BID ADDENDUM NO. (2)

3/5/26

Prattsburgh Central School District
2025 Capital Improvements Project
2716-043

The following Addendum items shall be considered a part of the contract documents prepared by HUNT ENGINEERS, ARCHITECTS, LAND SURVEYORS & LANDSCAPE ARCHITECT, DPC. Bid Document date of (12/18/2025).

11 SECTION @ EXHAUST VENTILATOR
 1 1/2" = 1'-0"

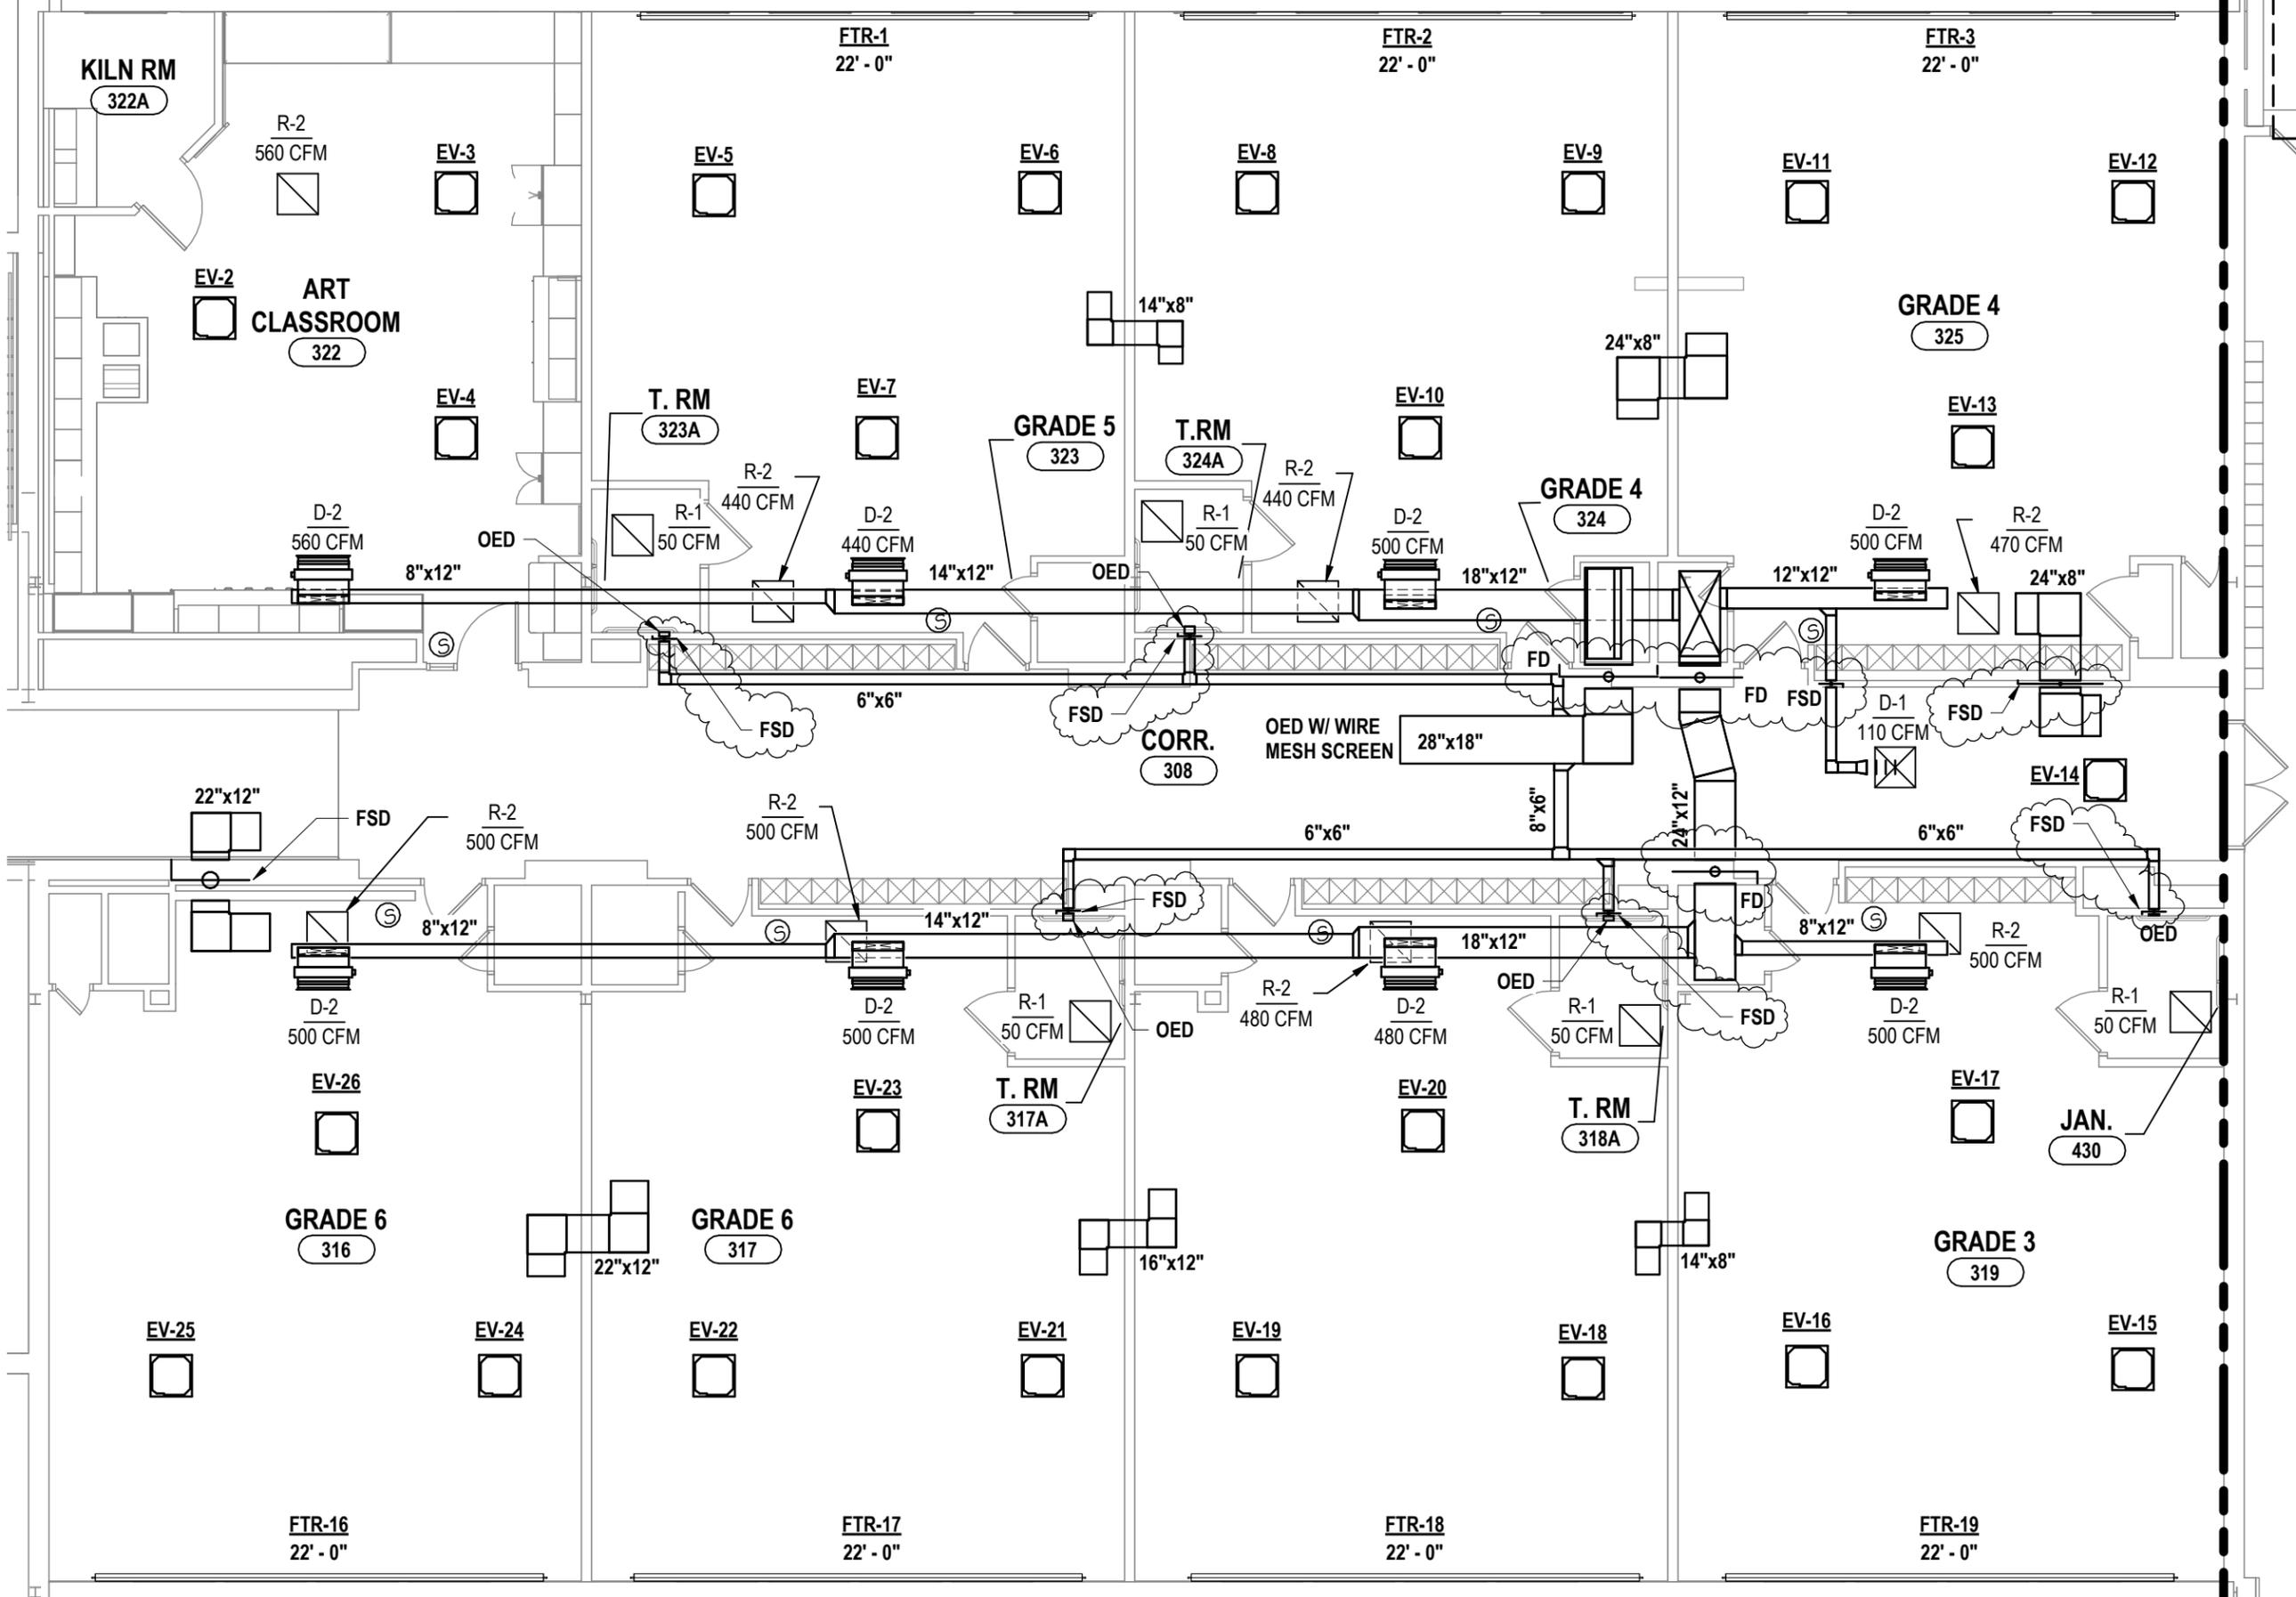
ITEM AD2-25 Refer to Drawing TR-A3.2 BUILDING SECTIONS & DETAILS

ADD Detail 1 from AD2-A6 – SECTION @ EXHAUST VENTILATOR as issued by this addendum.

① **MODIFICATIONS TO CORRIDOR 308 DUCTWORK**
 1/8" = 1'-0"

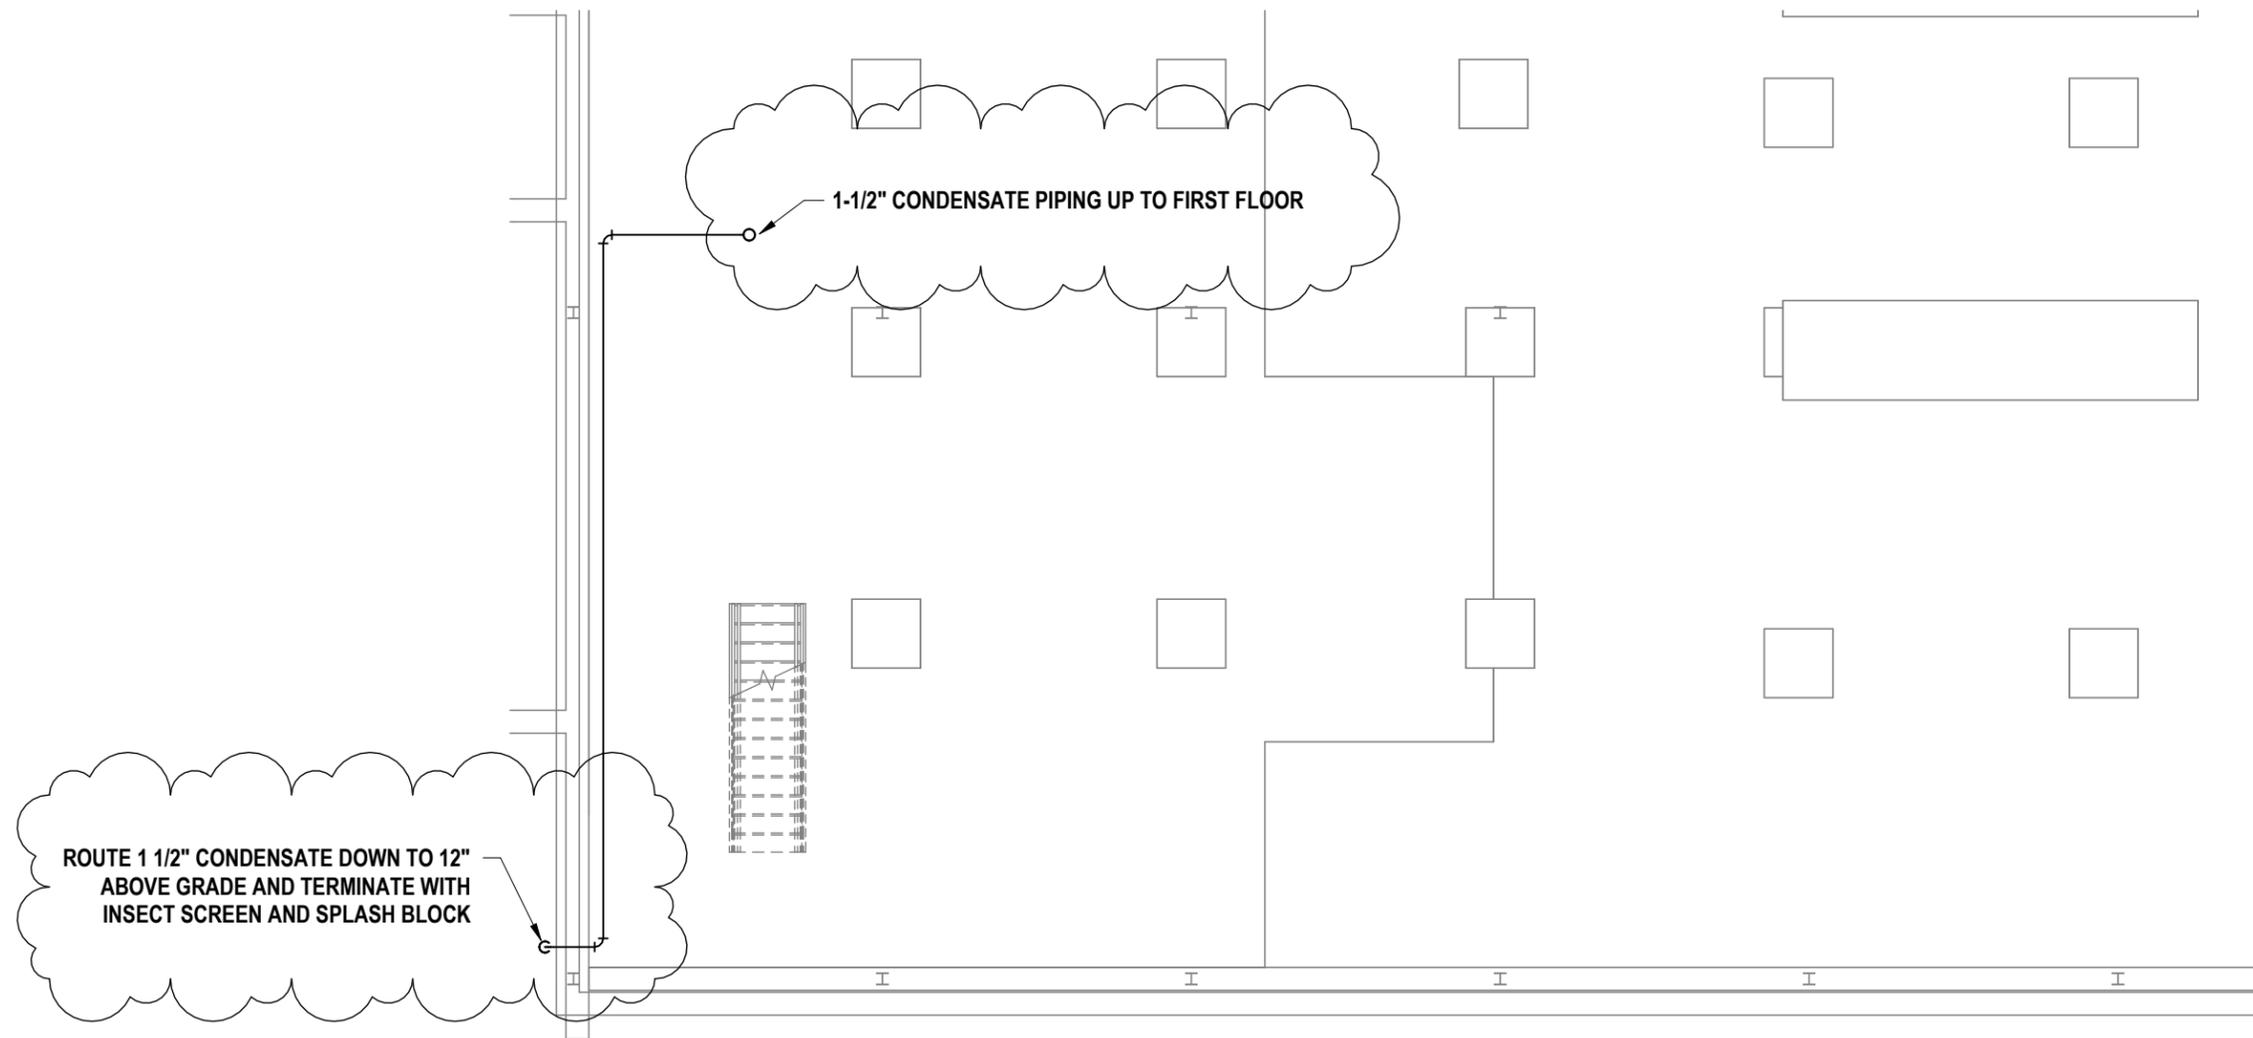
ITEM AD2-27 Refer to Drawing MB-H1.4 – SECOND FLOOR NEW WORK PLAN – AREA B & C

AMEND Scope of work to include changes shown on AD2-H1 – MODIFICATIONS TO CORRIDOR 308 DUCTWORK issued in this addendum.

① BASEMENT PIPING PLAN MODIFICATIONS
1/8" = 1'-0"

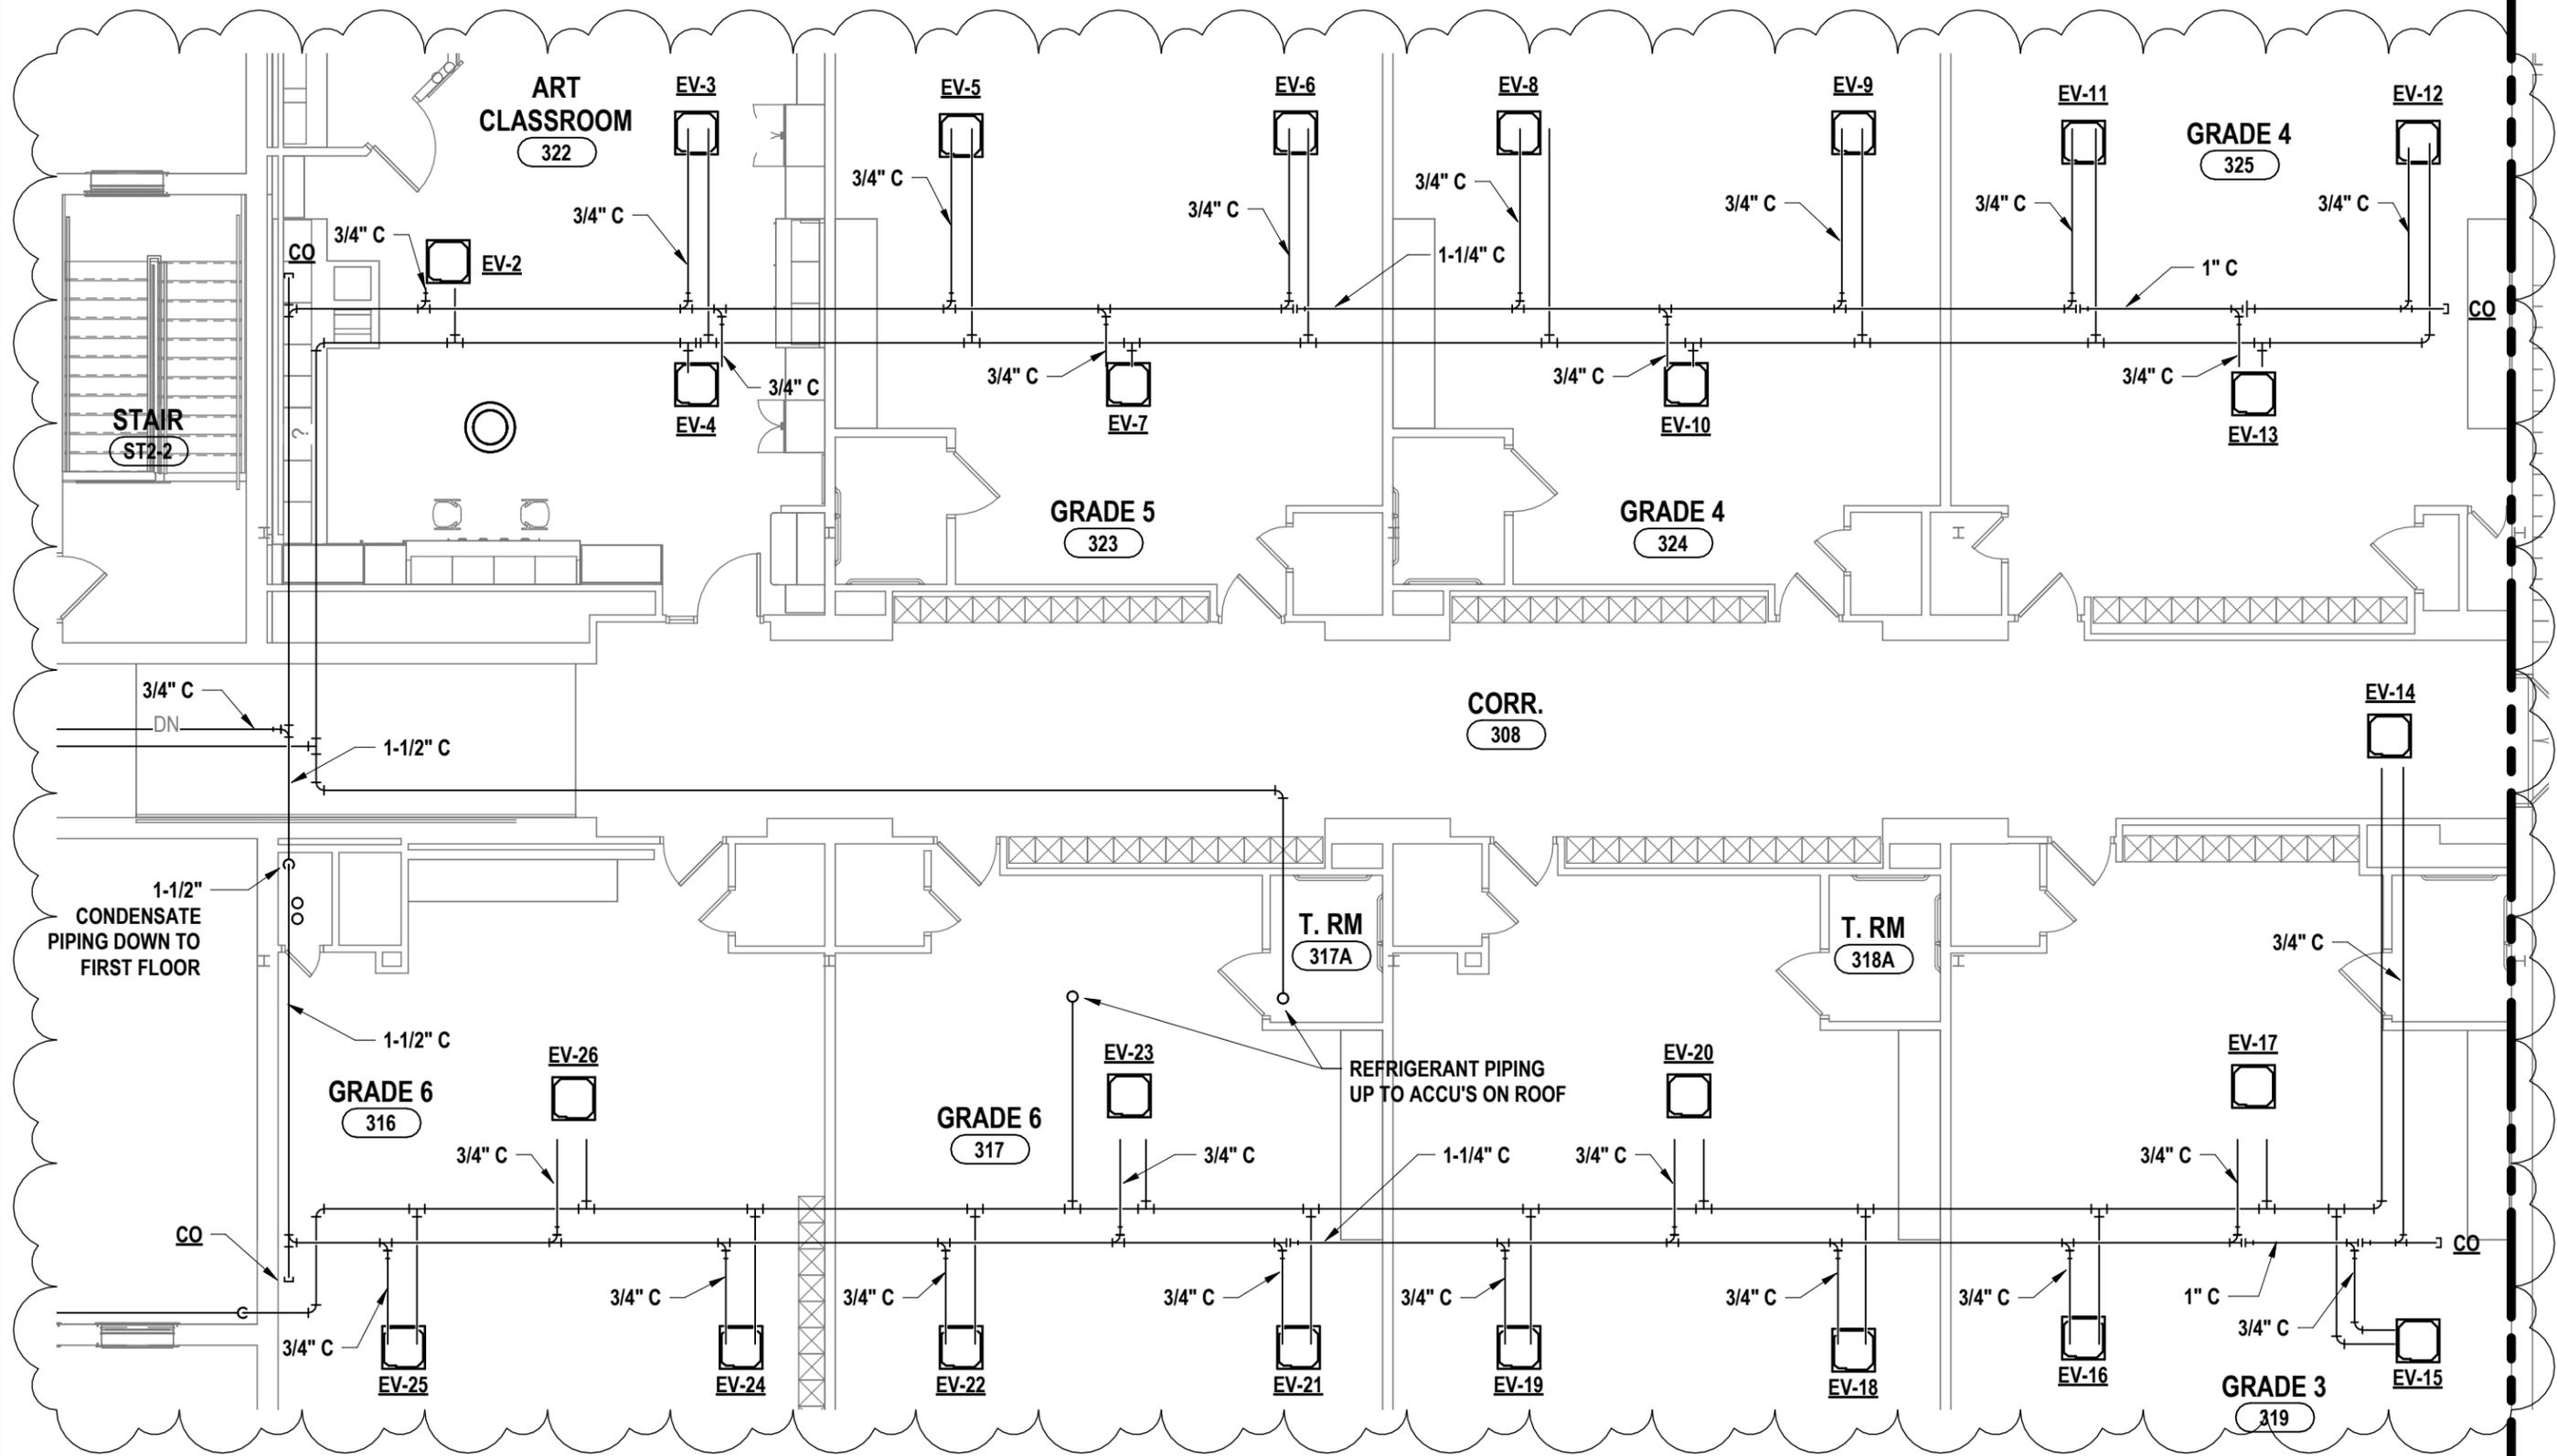
ITEM AD2-28 Refer to Drawing MB-H2.1 – GROUND FLOOR PIPING PLAN

AMEND Detail #1 as shown on AD2-H2 – BASEMENT CONDENSATE SIZING as issued by this addendum.
